# APPENDIX H

## Traffic Safety Audit

<b>PRELIMINARY CONCEPT PLAN ROAD SAFETY AUDIT</b>	<b>17 Street RSA</b>
<b>Date:</b>	<b>November 21, 2012</b>
<b>Our Reference:</b>	<b>2131-00156-0</b>

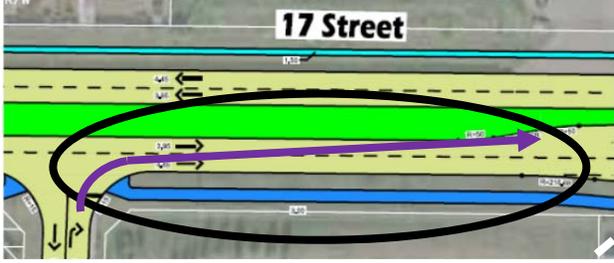
No.	Potential Safety Issue	Descriptive Reference Photograph
1	<p>Short weaving distance for vehicles exiting WB Whitemud Drive who wish to turn left into the future development access.</p> <p>Short weaving distances increase the risk of side swipe and rear-end collisions.</p>	 <p><i>N. of Whitemud Dr. to future development access</i></p>
2	<p>Several bus stops are located in close proximity to intersections. Motorists may not anticipate traffic stopping in such close proximity to the intersection, which could result in rear-end collisions or queuing into the intersections.</p> <p>Storage for at least 1-2 vehicles should be provided behind bus stops.</p>	 <p><i>Future development access (S. of 51 Avenue)</i></p>
3	<p>No sidewalk connection to the bus stop north of 76 Avenue is proposed. As a result, pedestrians would be required to walk on the street or through the field, both of which pose a hazard to pedestrians.</p> <p>A sidewalk connection should be provided to the bus stop.</p>	 <p><i>17 Street / 76 Avenue Intersection</i></p>

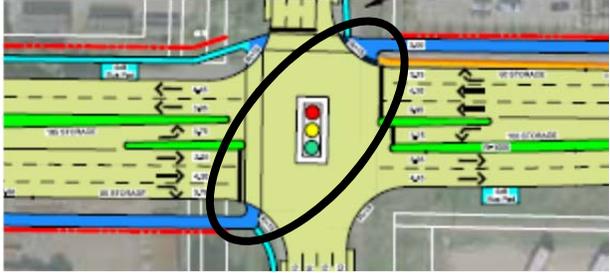
No.	Potential Safety Issue	Descriptive Reference Photograph
4	<p>Wide travel lanes on 17 Street could encourage speeding. Particularly in combination with the predominantly straight and flat alignment of the road. It is assumed that some lanes are intended for shared use with transit and/or bicycles, but even then the width appears excessive.</p> <p>Vehicle lane widths greater than 3.7m and shared lanes wider than 4.2m should be carefully reviewed.</p>	 <p style="text-align: center;"><i>Typical Cross Sections</i></p>
5	<p>It is unclear if left turns are permitted from the snow dump access onto 17 Street. Left turn movements would require numerous through lanes to be crossed, resulting in numerous conflict points. Through traffic may not anticipate left-turn traffic at such a large uncontrolled intersection. NB traffic in the left lane may also not anticipate a preceding vehicle to slow or stop to make a left turn.</p> <p>Consideration should be given to right-in/right-out access (for one leg or both), access management or signals.</p>	 <p style="text-align: center;"><i>17 Street / Snow Dump Access Road Intersection</i></p>

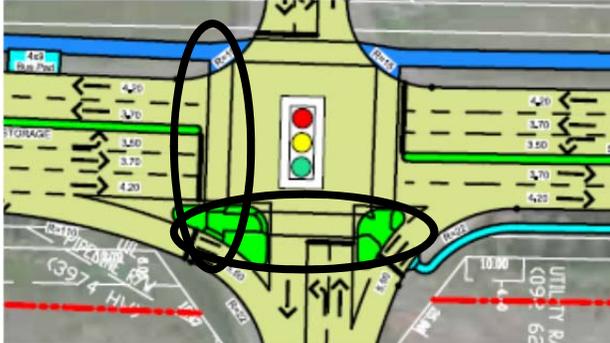
6	<p>The entrance tapers for the left turn lanes at the intersection of 17 Ave and Roper Road are rather sharp. The sharp change in alignment increases the potential for loss of control, side swipes and challenges for trucks.</p> <p>The possibility of increasing the taper ratio should be explored.</p>	 <p style="text-align: center;"><i>17 Street / Roper Road Intersection</i></p>

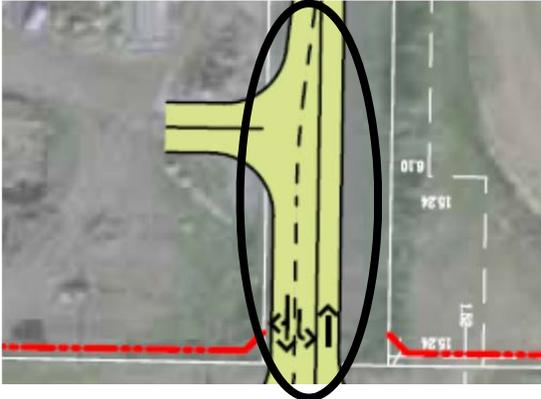
No.	Potential Safety Issue	Descriptive Reference Photograph
7	<p>The right NB through lane ends at Roper Road after being present for an extended length and could potentially catch motorists off-guard (even with signage). Sudden lane changes could result in rear-end and sideswipe collisions.</p> <p>Consideration could be given to ending the lane further south and reintroducing it as an exclusive right turn bay.</p>	 <p>17 Street/Roper Road Intersection</p>
8	<p>Reduced separation is provided between the travel lanes and sidewalk near Maple Ridge Drive due to constraints to the west. The reduced separation will decrease pedestrian comfort and increases the risk of pedestrian collisions.</p> <p>Increasing the separation is desirable. However, if this is not feasible, a monolithic sidewalk is still acceptable for a posted speed limit of 60 km/h.</p>	 <p>17 Street South of Maple Ridge Drive</p>

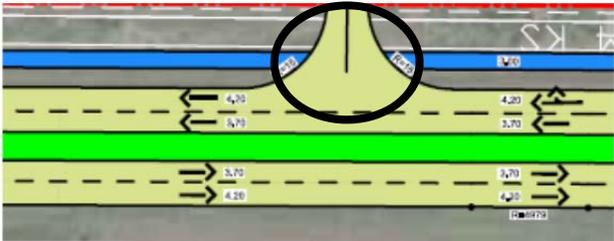
9	<p>The alignment of the trail ramps at the intersection of 68 Ave directs cyclists and pedestrians into the center of the intersection.</p> <p>A tangent alignment is preferred. However, a straight alignment could discourage cyclists from stopping/slowing to look for conflicting traffic at the intersection. Consideration could be given to using speed reduction gates to encourage cyclists to check for traffic.</p>	 <p>17 Street / 68 Avenue Intersection</p>

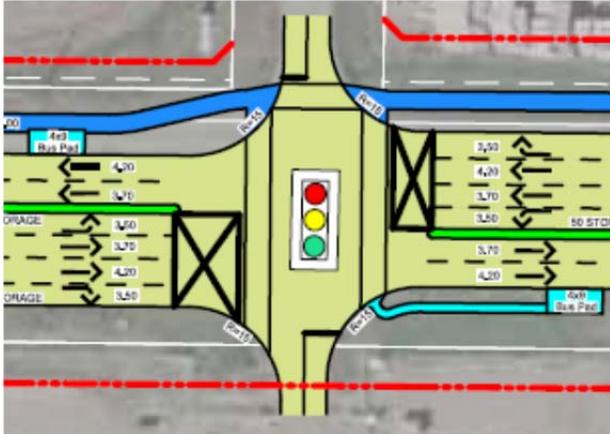
No.	Potential Safety Issue	Descriptive Reference Photograph
10	<p>Short weaving distance for WB right turning vehicles from 68 Avenue who wish to turn left at 70 Avenue. Although this may be a low volume movement, short weaving distances increase the risk of side swipe and rear-end collisions.</p> <p>Consideration could be given to closing the RIRO at 68 Avenue, redirecting traffic to Oak Ridge Dr. Traffic analysis would be required to determine the impact on operations.</p>	 <p>WB 68 Avenue to WB 70 Avenue</p>
11	<p>There is limited separation between 76 Avenue and the intersection to the north on 18 Street. Motorists may not anticipate braking and turning movements in such close proximity to the preceding intersection. There is also the risk that vehicle queues will extend into the preceding intersection. In addition, the skewed intersection results in a large pavement area, which will likely make it difficult for motorists to identify proper turning paths.</p> <p>Alternate access configurations could be considered, but it appears few, if any, alternate options are available.</p>	 <p>18 Street north of 76 Avenue</p>

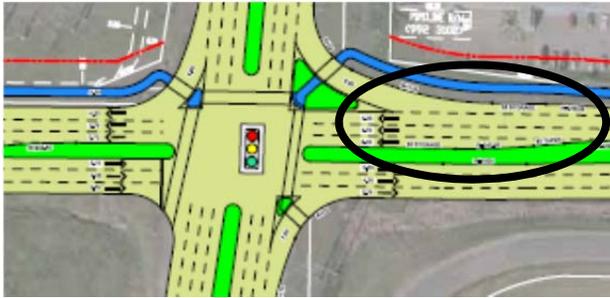
12	<p>Sharp horizontal curves on the Access Road north of the 76 Avenue increases the risk of run-off-road or head-on collisions.</p> <p>Consideration should be given to increasing the radius of the curves or realigning the proposed access road to a straighter alignment.</p>	 <p>Access Road North of 76 Avenue intersection</p>

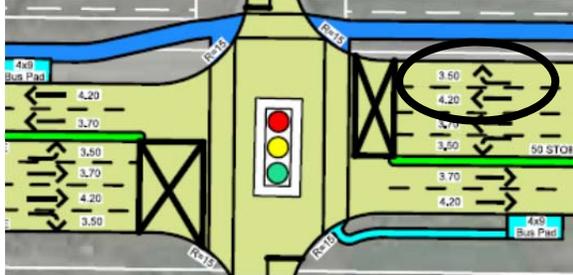
No.	Potential Safety Issue	Descriptive Reference Photograph
13	<p>The shared use path changes from one side of 17 Street to the other at the intersections of 76 Avenue and the Future Development Access north of Whitemud Drive.</p> <p>The disjointed alignment does not help promote active modes and increases the number of crossings required. It may also encourage some cyclists to travel on the sidewalk, which is not wide enough to accommodate them and pedestrians.</p> <p>It is acknowledged that the need to relocate the trail is based on constraints such as the location of trail crossings on bridges outside of this study area and right-of-way constraints in the vicinity of Maple Ridge Dr.</p>	 <p>17 Street / 76 Avenue intersection</p>
14	<p>Vertical curve k values on 17 Street near Baseline Road do not meet minimum standards and may result in substandard sight distances.</p> <p>The vertical profile should be reviewed to confirm there is no feasible way to achieve minimum k values.</p>	 <p>17 Street Profile at Baseline Road</p>

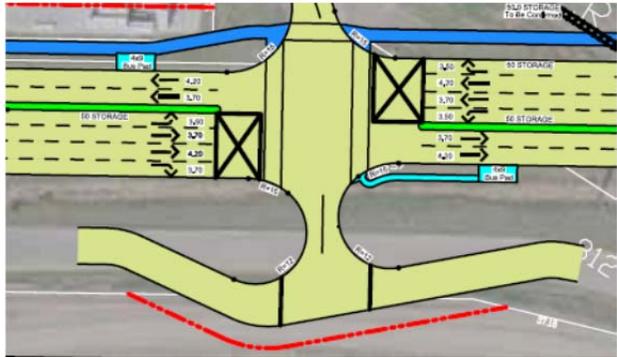
15	<p>Some of the cross walks/ramps provided at the Envirofuels Refinery, Baseline Road, Railway Street, 92 Avenue and 90 Avenue intersections do not connect with pedestrian facilities. It is assumed these facilities may be planned in the future.</p> <p>Crosswalks should not be implemented until there are corresponding facilities on both sides.</p>	 <p>17 Street / 90 Avenue Intersection</p>
